POWER DRIVEN ROTARY SELECTORS  
 TOGETHER WITH ASSOCIATED BANKS

1.01 This addendum covers a change in the requirement covering alignment of tips of rotor brushes, a change in the requirement covering toeing of bridging brushes and also covers requirements for feeder brushes having the prongs bent in the opposite directions (balanced type). It supplements Section A468.004, Issue 1-D, and replaces Addendum A468.004, Issue 1-B. It is reissued to add requirements for feeder brushes having the prongs bent in opposite directions and to revise the requirement covering toeing of bridging brushes. Detailed reasons for reissue will be found at the end of the parts effected.

Fig. 1

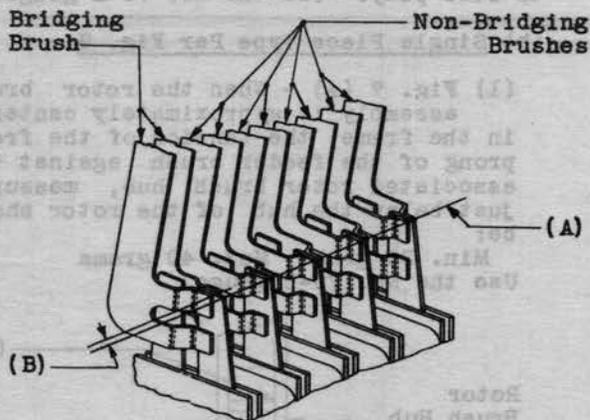
2.21 Alignment of Tips of Rotor Brushes

(a) Fig. 1 (A) - The trailing edges or tips of all non-bridging brush members shall be in approximate (within .010") alignment with a plane passing longitudinally through the rotor shaft. Gauge by eye.

(b) Fig. 1 (B) - The trailing edges or tips of the bridging brush members shall be advanced in the direction of normal rotation beyond the plane referred to in (a) as follows:

- 202-E and 203 type selectors - Min. .010", Max. .020"
  - 202-C and 202-D selectors - Min. 1/32", Max. 3/64"
  - 207 and 208 type selectors - Min. .000", Max. .010"
- Gauge by eye.

Fig. 2

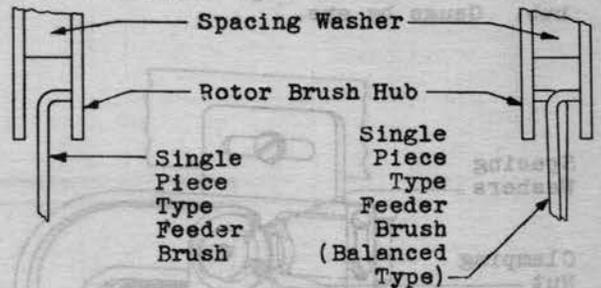
2.23 Feeder Brush Position Each feeder brush shall meet the requirements listed in the following table for the particular type of feeder brushes involved:

(a) Fig. 5 (A) - Single Piece Type Per Fig. 2 The tension of each feeder brush against the associated rotor brush hub measured at a point on the center line of the feeder brush and close to the crotch shall be:

(8) Single Piece Type Feeder Brushes Per Fig. 2 Rotate the selector to a position where the feeder brushes are readily accessible and also where the rotor

Fig. 5

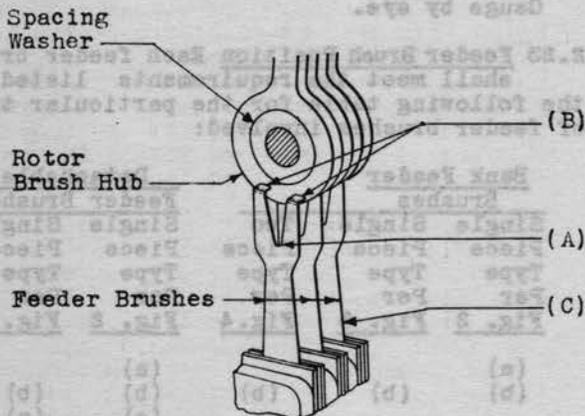
(a) Fig. 5 (A) - When the feeder brush is pushed away from the rotor with pressure applied on the center line of the feeder brush and close to the crotch, the two prongs shall leave the rotor at the same time. Gauge by eye.

(b) Fig. 5 (B) - The prongs of the feeder brush shall not interfere with the spacing washers on the rotor at any point in the revolution of the rotor. Gauge by eye.

(e) Fig. 5 (C) - That part of the bank feeder brush over which the rotor brushes pass shall be in alignment with the bank terminals within .010". Gauge by eye.

Fig. 6

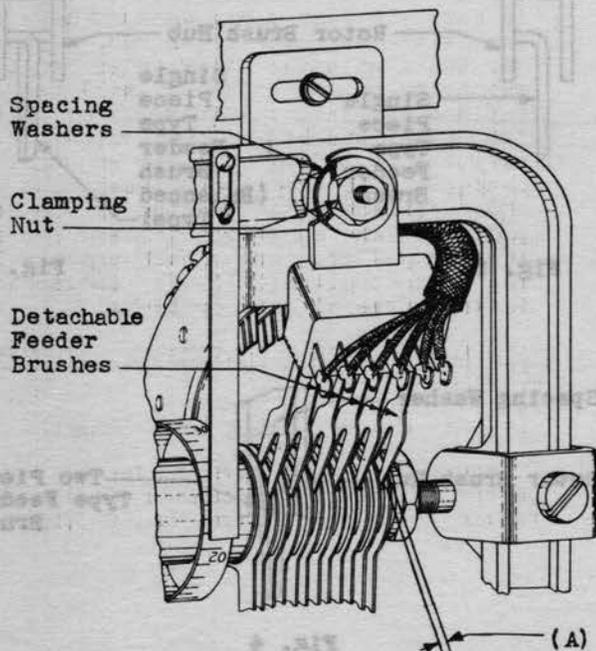
(c) Fig. 6 (A) - The points of contact between the feeder brushes and the rotor brush hub shall be Min. 1/64" within the outside edge of the rotor brush hub. Gauge by eye.

Fig. 7

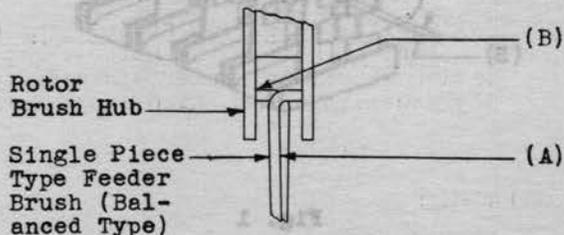
(1) Fig. 7 (A) - When the rotor brush assembly is approximately centered in the frame, the tension of the front prong of the feeder brush against the associated rotor brush hub, measured just below the hub of the rotor shall be:

Min. 25 grams, Max. 40 grams  
 Use the No. 70-D gauge.

(2) Fig. 7 (B) - The rear prong shall make contact with the rotor brush hub. Gauge by eye and by feel.
